DEER PORT COMMERCE PARK SUBDIVISION

APPLICATION NUMBER 6 DATE September 1, 2005

DETAIL SITE PLAN

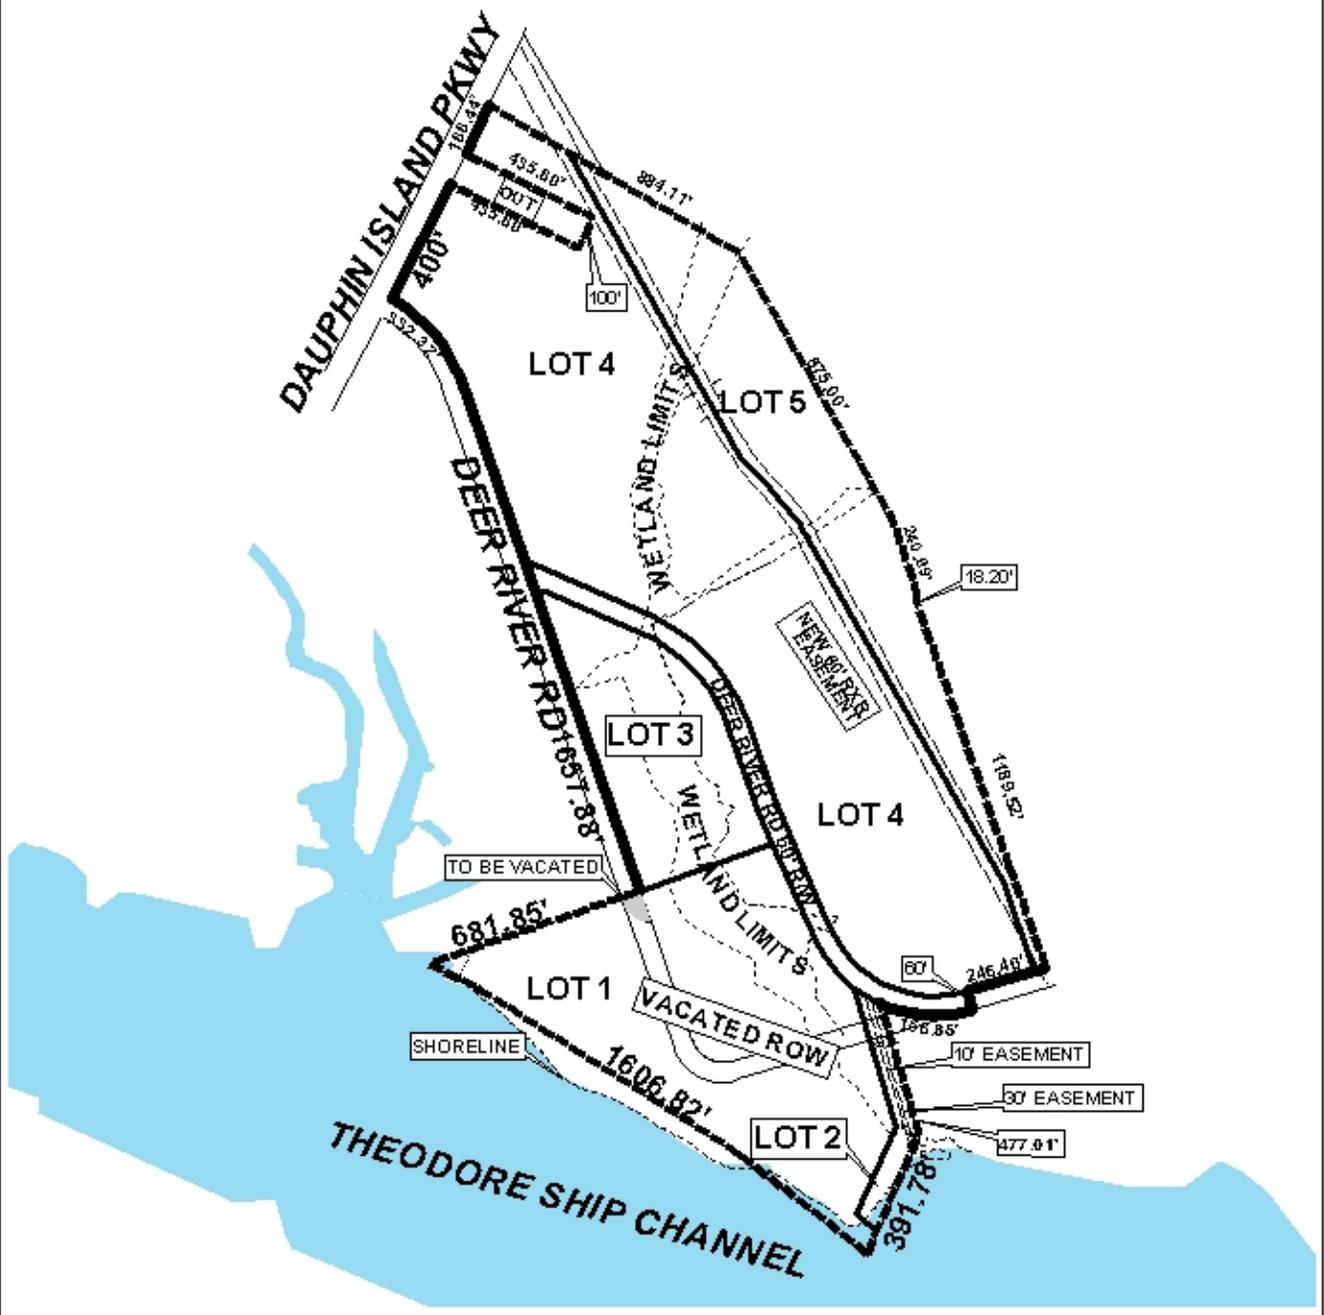
As illustrated on the Detail Site Plan, wetlands are prominent throughout the site, therefore, the area could be considered environmentally sensitive. Permits from all applicable federal, state and local agencies should be obtained prior to permitting.
